CYNTHIA QUINLEY SUBDIVISION

APPLICATION NUMBER 20 DATE October 4, 2012

REQUEST Subdivision

DETAIL SITE PLAN

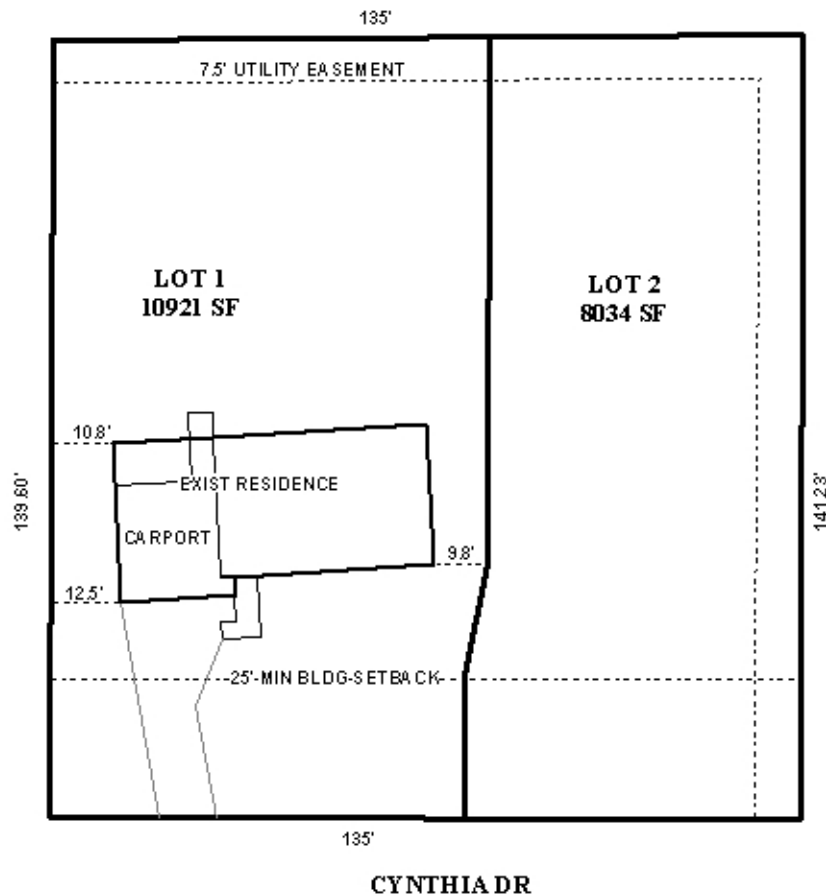
Engineering Comments: The following comments should be addressed prior to acceptance and signature by the City Engineer: 1. Provide all of the required information on the Final Plat (i.e. signature blocks, signatures, certification statements, legal description, required notes). 2. Add the existing shed onto the drawing and correct the area of the dwelling labeled "CARPORT". 3. A signature block and signature for the Traffic Engineering Department shall be placed on the Final Plat. 4. Label Old Shell Road in the vicinity map.

The legal description is not on the preliminary plat; therefore, the plat should be revised to include the legal description.

Cynthia Drive is a minor street with a compliant 50' right-of-way; therefore, no dedication would be required. As Cynthia Drive is a closed-end street, a turn-around would normally be required if not currently provided. However, Fire Department correspondence concerning this matter indicates that none would be required if acceptable with Traffic Engineering and City Engineering. And due to existing development within the immediate area, this would not be possible. As a means of access management, a note should be required on the Final Plat stating that each lot is limited to one curb cut to Cynthia Drive, with the size, location and design to be approved by Traffic Engineering and conform to AASHTO standards. As on the preliminary plat, the Final Plat should illustrate the 25' minimum building setback line along Cynthia Drive. The plat should be revised to label each lot with its size in both square feet and acres, or a table should be furnished on the Final Plat providing the same information.

- 1) revision of the plat to include the legal description of the property being subdivided;
- 2) placement of a note on the Final Plat stating that each lot is limited to one curb cut to Cynthia Drive, with its size, location and design to be approved by Traffic Engineering and conform to AASHTO standards;

- 3) illustration of the 25' minimum building setback line along Cynthia Drive;
- 4) revision of the plat to label each lot with its size in both square feet and acres, or the furnishing of a table on the Final Plat providing the same information;
